Access Compliance Report Public Rights-of-Way (Curb Ramps)

Main Street: LASSEN_DR Cross Street: ESPLANADE_AVE Location: NW

ADA ID: RPAT211026140300 Ramp Type: Type 1 - Perpendicular Diagonal Initial Pass/Fail: Fail Overall Compliance: No Severity Score: 15

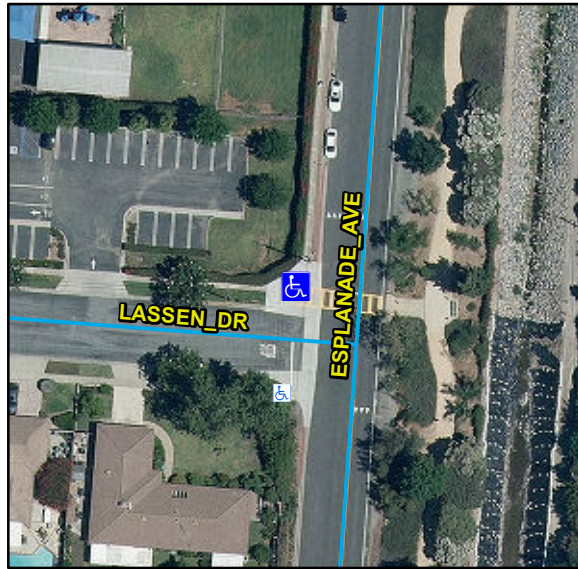
Remove & Replace Curb Ramp With Two New Directional Ramps or Equivalent.

R304.2.2, STD 1115
